SERVICE BULLETIN 82 SUPPLEMENT A

SUBJECT: REWORKING THE GLASAIR III 90° INDUCTION ELBOW

APPLICATION: All Glasair III 90° induction elbows and support arms shipped before 10/8/90

FIGURE (1)

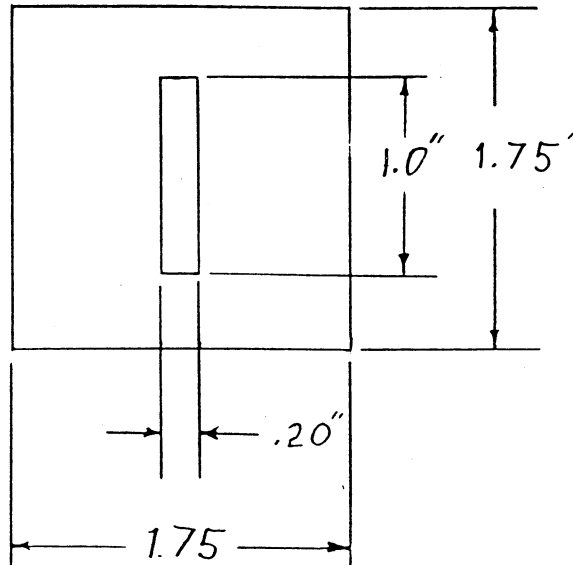
Cracking found at the base of the welded control cable mounting tab in the two instances originally reported may have been the result of the metal being stretched too thin during the tube bending process to properly support the tab. To reinforce these areas, weld a 4130 steel sheet reinforcement patch around each of the control cable mounting tabs. The reinforcement patches must be slotted to slip over the tabs and formed to match the curvature of the tube by heating with a torch and hammering into shape.

Remove the cadmium plate in the areas where the welding will be done, and weld the patches to the elbow and all around the tabs. After welding, paint the elbow with an epoxy primer to protect against corrosion.

**WARNING:** Cadmium plating must be removed before welding; otherwise dangerous cyanide gas may be released by the heat of welding.

**NOTE:** If one of the control cable attach tabs is too short to accommodate the patch, cut off the tab and fabricate a new, slightly longer one from .125" thick 4130 steel sheet. Reweld the new tab in the same location and at the same angle as the original tab before welding the patch in place. This sequence ensures that the tab is attached to both layers of material for maximum strength.
